September 18, 2017

Project No.: 5077

Regarding: Clarification Response to Third Party Geotechnical Review (exp Services Inc. – July 25, 2017)  
Site Location: 1430 South Island Hwy, Campbell River, BC  
Project Description: Proposed 6-level Residential Development

Section B – current site condition without proposed slope measures, pseudo static  
FS <1.5 shown. Note, all Slip surfaces exceed FS >1.1

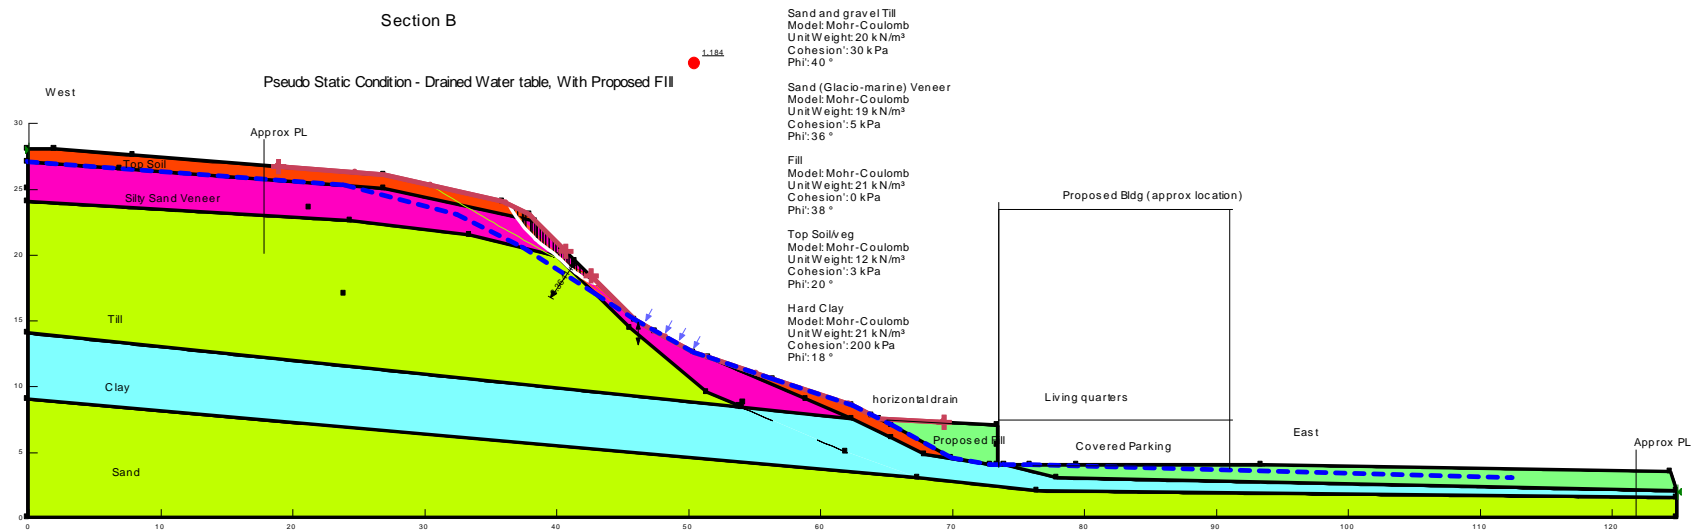
Overall global stability for pseudo-static and static stability meets or exceeds the minimum factor of safety. There are local surficial small slip surfaces within the top soil and sand veneer less than the minimum factor of safety which were presented in the geotechnical investigation report.

Section B – current site condition with proposed slope measures (Soil nail, interceptor ditch, horizontal drains), pseudo static  
 Failure surface below soil nail system shown (FS=1.71)

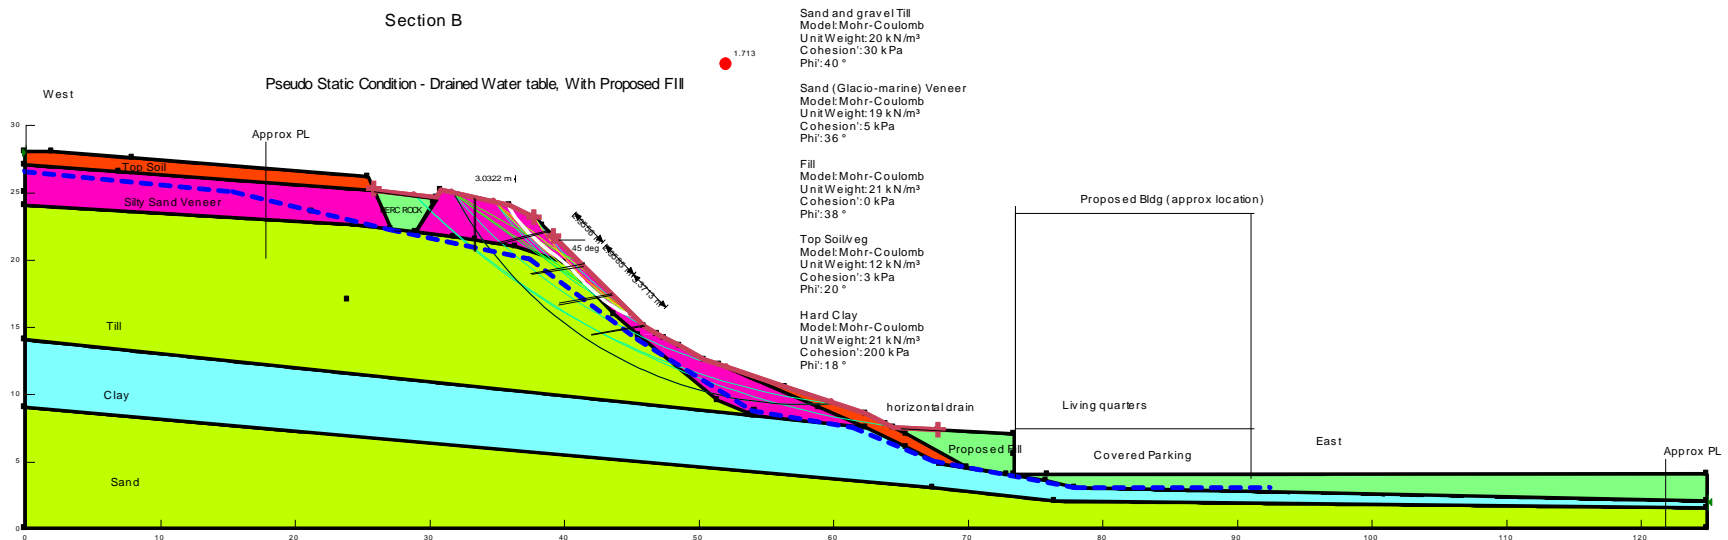
TerranGeo agrees rapid mudflow forms part of the overall landslide failure mechanisms that occurred on this site in the past. The landslide that occurred on the site is complex in nature and likely involved a combination of mudflow, translational slides, and rotational slides due to catalytic factors such as storms, land regrading, and development as discussed in the geotechnical report.

TerranGeo believes the mudflow hazard can be reduced to acceptable levels as indicated by the attached stability model by installing an interceptor ditch at the top of slope to capture groundwater seepage and overland flows, and installing a high tensile steel mesh/soil nail system to stabilize steep as conceptually shown in TerranGeo's Proposed Slope Improvement Drawing, September 11, 2017. High Tensile steel mesh and soil nail system have been used in the past to stabilize steep eroding slope in the Cowichan bay, BC by Ministry Transportation and Infrastructure (MOTI). Given the proposed slope improvement measures and case study by MOTI, a runout zone is not required at the bottom of slope.
